DESIGN	RF	DART AEROSPACE USA, INC. KENT, WA	
DRAWN	DL		
CHECKED		DRAWING NO. D3901	REV. PD4 SHEET 4 OF 4
MFG. APPR.		TITLE BAR	SCALE NTS
APPROVED			
DE APPR.			
DATE	12.08.21	COPYRIGHT © 2009 BY DART AEROSPACE USA, INC. THIS DOCUMENT IS PRIVATE AND CONFIDENTIAL AND IS SUPPLIED ON THE EXPRESS CONDITION THAT IT IS NOT TO BE USED FOR ANY PURPOSE OR COPIED OR COMMUNICATED TO ANY OTHER PERSON WITHOUT WRITTEN PERMISSION FROM DART AEROSPACE USA, INC.

PRELIMINARY ISSUE
JC 12.08.21

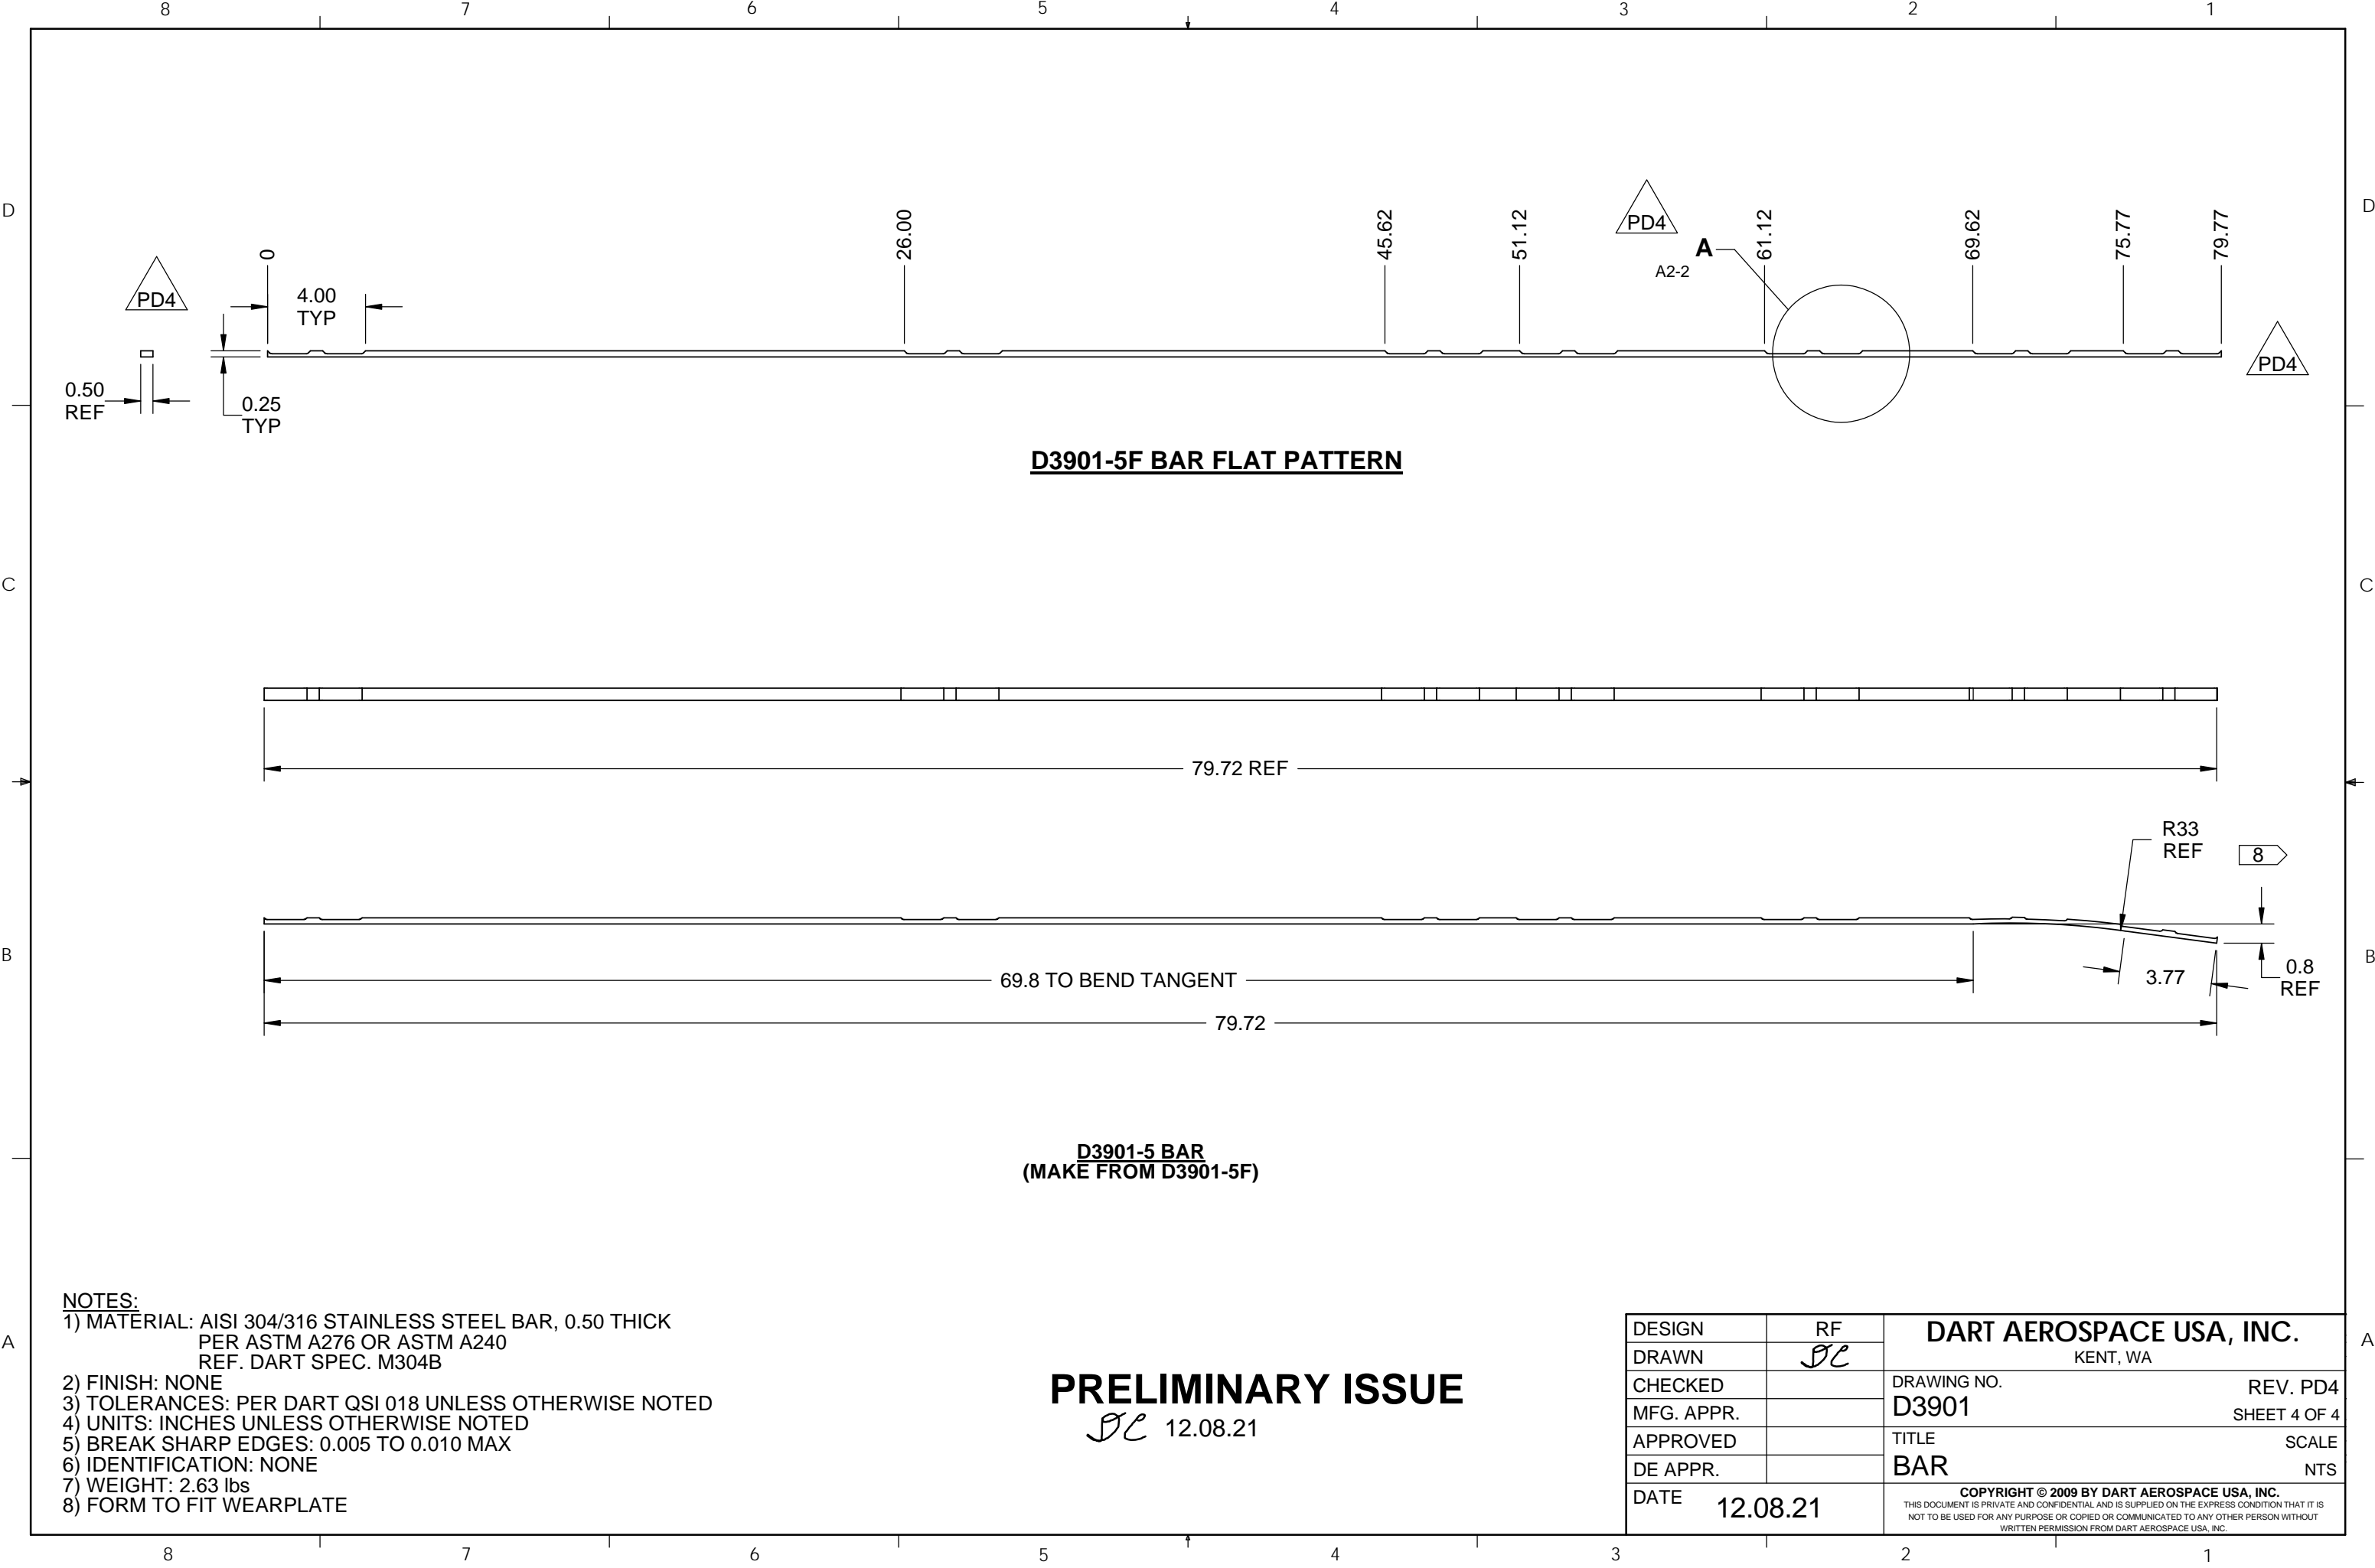
PD4	CHANGE LOCATION OF END POCKETS ON -1/-3/-5 (ZN D1-2, D8-2, B7-3, B2-3, D1-4, D8-4). SPLIT POCKETS INTO TWO SEPARATE POCKETS (ZN A2-2). ADD POCKET TO -1 (ZN D6-2).	DC	12.08.21
C	0.25 WAS 0.20 AND 0.130 WAS 0.080 (ZN B2-2, B1-2, B1-3, D8-4); ADD MISSING DIMENSIONS (ZN C5-3); ADD D3901-1F/-5F FLAT PATTERN	RF	12.01.24
B	REMOVE \varnothing 0.188 HOLES FROM D3901-1/-3/-5; 62.12 WAS 62.61 (ZN C4-3)	RF	09.06.30
A	NEW ISSUE	RF	09.03.30
REV.	DESCRIPTION	BY	DATE
DESIGN	RF	DART AEROSPACE USA, INC. KENT, WA	
DRAWN	JC		
CHECKED		DRAWING NO. REV. PD4	
MFG. APPR.		D3901 SHEET 1 OF 4	
APPROVED		TITLE SCALE	
DE APPR.		BAR NTS	
DATE	12.08.21	COPYRIGHT © 2009 BY DART AEROSPACE USA, INC. <small>THIS DOCUMENT IS PRIVATE AND CONFIDENTIAL AND IS SUPPLIED ON THE EXPRESS CONDITION THAT IT IS NOT TO BE USED FOR ANY PURPOSE OR COPIED OR COMMUNICATED TO ANY OTHER PERSON WITHOUT WRITTEN PERMISSION FROM DART AEROSPACE USA, INC.</small>
